SUBJECT: Scientia Project - Monte Sant' Angelo Mercy College
Acoustic Addendum Report - Sydney Metro Acoustic Conditions B7, B8
and B9

Re: Monte-SSBP RFP-Response to Submissions - Acoustics

SCIENTIA PROJECT
MONTE SANT ANGELO MERCY COLLEGE
PROJECT APPLICATION
CONSTRUCTION & OPERATIONAL NOISE REPORT

Figure 2 Cross Section 1 – Northern

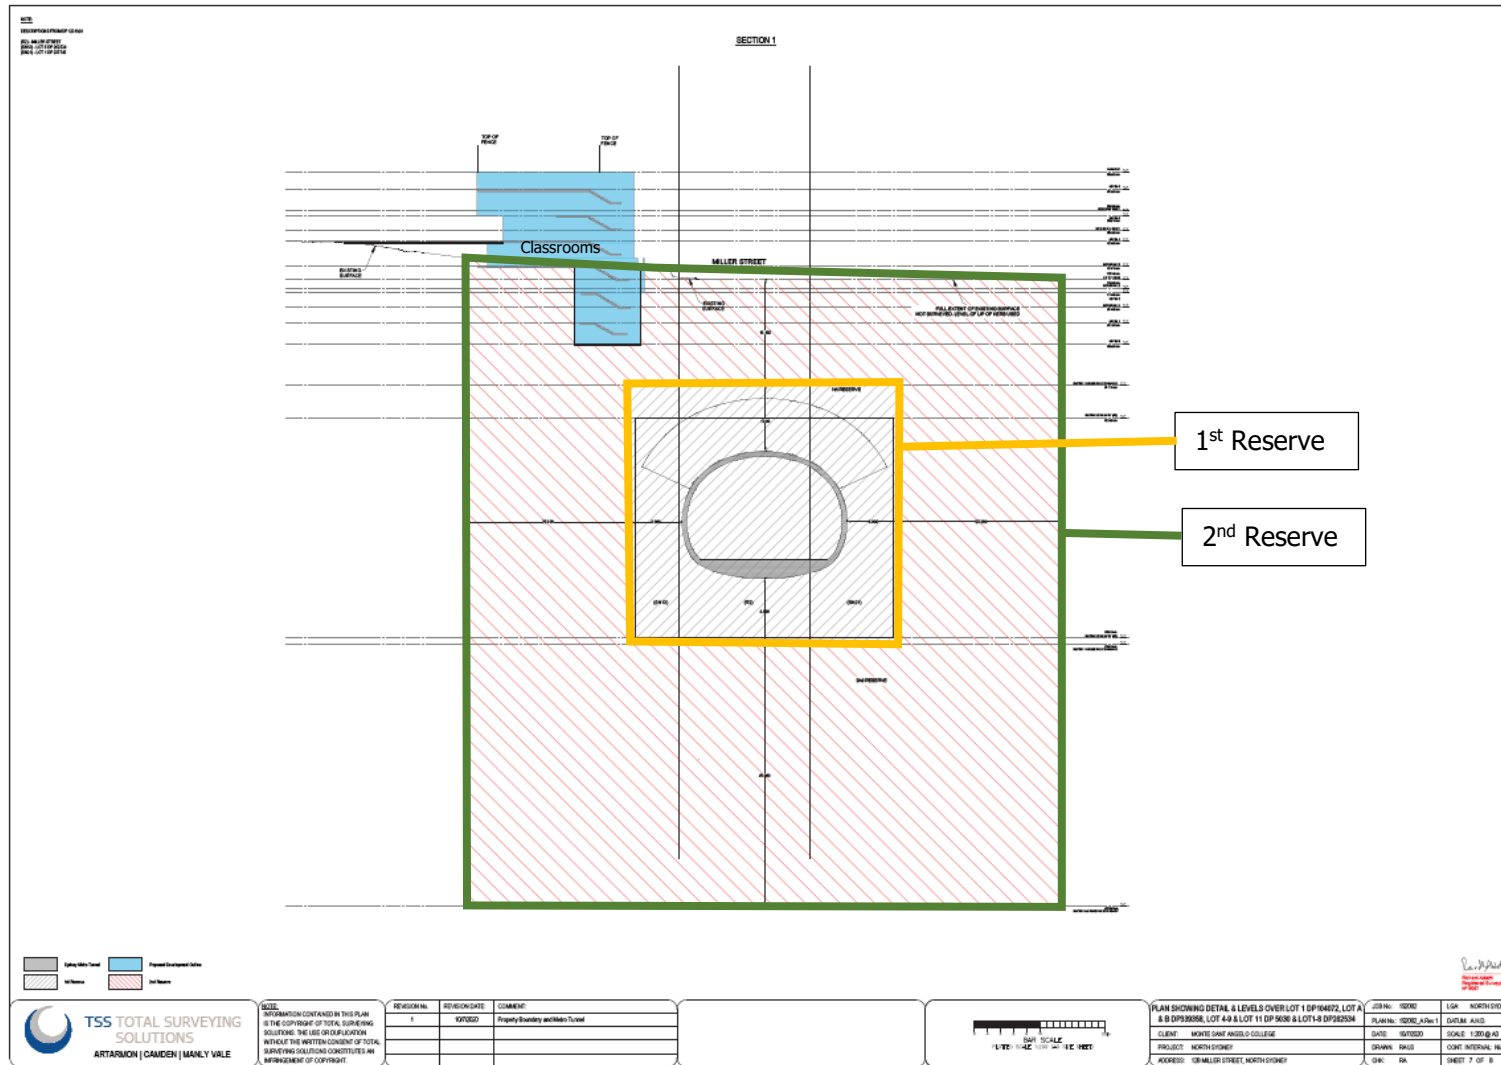
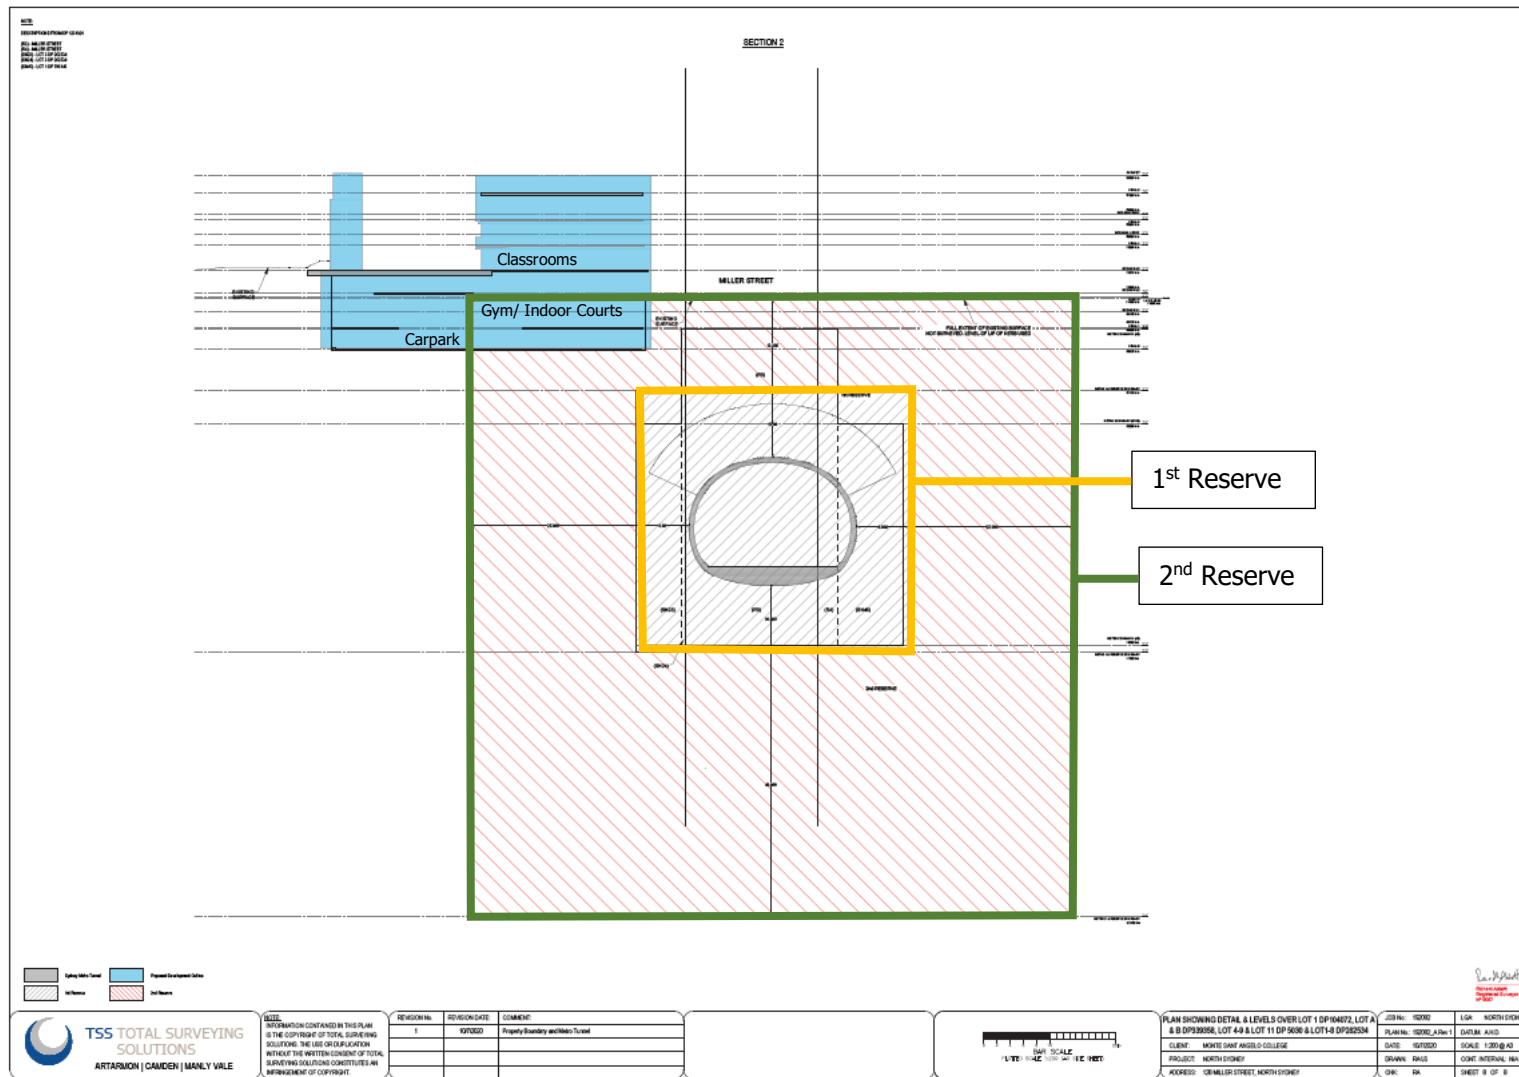
b) an assessment of the impact levels of the proposal on Sydney Metro infrastructure addressing the requirements of the Sydney Metro Underground Corridor Protection Guidelines (available on www.sydneymetro.info);	See "Noise Criteria" Section.

#	Condition	Where in the report the condition is responded to.
d)	demonstration that the development can be designed and constructed to avoid any damage or other interference due to air-borne noise, ground-born noise and vibration effects due to the rail corridor, during the rail construction and future operation;	See "Calculations of Groundborne Rail Noise within the School" Section.

A plan of the new Sports and Science Building at Monte with respect to the rail alignment is shown in Figure 1. Victoria Cross Station is adjacent to the site. Figures 2 and 3 show cross sections of the tunnel and the proposed building. It can be seen from Figure 2 and Figure 3, that the proposed building intrudes into the 2nd Reserve of the Metro tunnel reserve but not the 1st Reserve.

It should be noted that the distance from the track to the closest point of the school is approximately 34 metres and the distance from the tunnel to the closest point of the school construction is approximately 21 metres.

With the modelling inputs listed above, it is expected that the regenerated rail noise in the ground floor classrooms would be less than 15dBA, significantly below the 40dBA criterion and is likely not going to be audible.

The vibration levels were calculated to be 0.02 vibration dose values ($\text{m/s}^{1.75}$) in the ground floor classrooms, significantly below the 0.4 VDV criterion and is likely not to be perceptible.

Figure 1 **Scientia and OSD Sites**

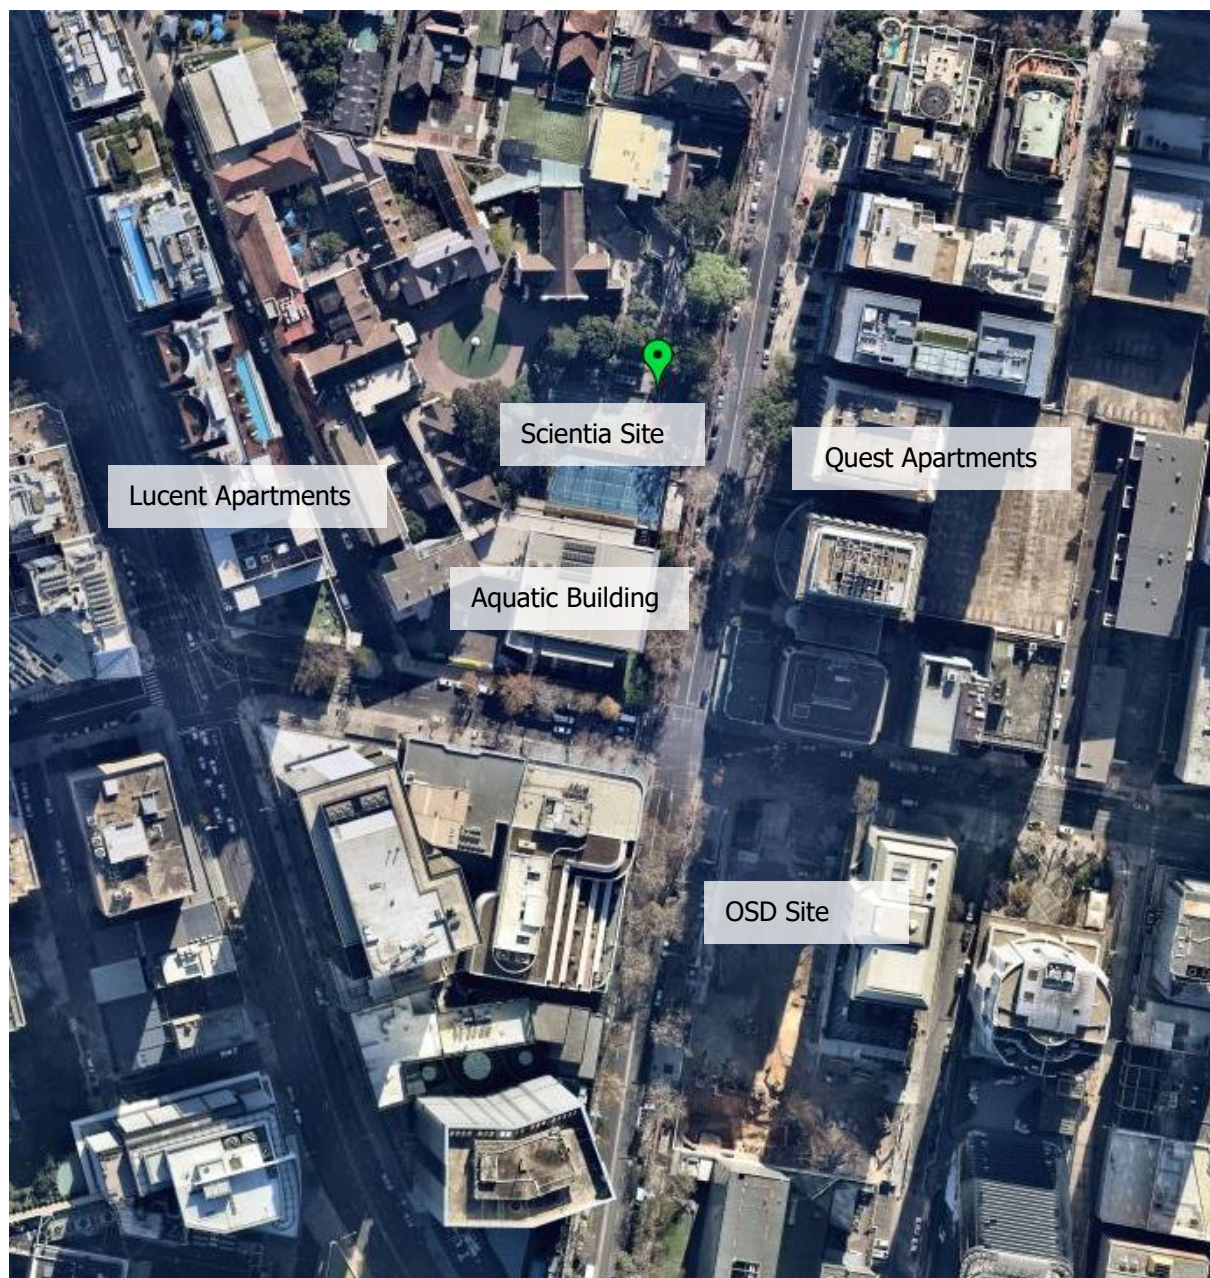
Item 3 ***Cumulative Construction Noise** - The construction noise assessment did not consider cumulative noise impact from other heavy truck movements. Wilkinson Murray to respond and assess cumulative construction noise impact; and*

Provide a cumulative assessment of construction impacts, in particular for noise and traffic impacts on the on-going operation of the school and adjacent businesses and residences, as a result of the proposed redevelopment.

In the case of cumulative construction noise it is noted that the OSD site is 90 metres to the south from the Scientia site and currently nearing the end of the excavation stage of the project . This is the stage that will generate the highest construction levels and therefore will not occur concurrently with the Scientia Project works.

In addition the intervening Aquatic Centre will shield the rest of the school from any OSD construction noise. Figure 1 shows this site.

Taking these factors into account construction noise from the OSD site at the school will be more than 10 dBA lower than predicted construction noise levels associated with the Scientia project. As such there will be no increase in construction noise at the school as a result of surrounding construction activities.
